FORM APPROVED  
OMB NO. 1004-0137  
Expires: January 31, 2018**SUNDRY NOTICES AND REPORTS ON WELLS**  
*Do not use this form for proposals to drill or to re-enter an abandoned well. Use form 3160-3 (APD) for such proposals.*5. Lease Serial No.  
NMNM45236

8. Well Name and No.  
IRIDIUM MDP1 28-21 FEDERAL COM 174+9. API Well No.  
30-015-45332-00-X110. Field and Pool or Exploratory Area  
INGLE WELLS - BONE SPRING11. County or Parish, State  
EDDY COUNTY, NM**SUBMIT IN TRIPLICATE - Other instructions on page 2**

This well has surface hole drilled and surface casing set. OXY USA Inc. respectfully requests approval to P&A this SH location. See the P&A plan below.

Permanent Abandonment of Federal Wells  
Conditions of Approval (LPC Habitat)

OXY USA Inc. - Proposed  
Iridium MDP1 28-21 Federal Com 174H  
API No. 30-025-45332

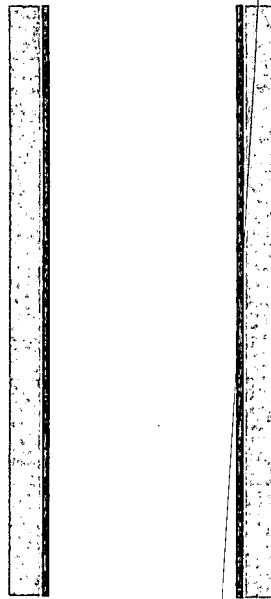
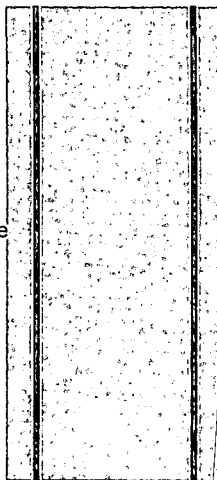
\*\* BLM REVISED \*\* BLM REVISED \*\* BLM REVISED \*\* BLM REVISED \*\* BLM REVISED \*\*

17-1/2" hole @ 544' ✓  
13-3/8" 54.5# csg @ 534' ✓  
w/ 830 sx-TOC-Surf Circ. ✓

NO Additional COA's  
SEE ATTACHED FOR  
CONDITIONS OF APPROVAL

Below ground level dry hole marker required.
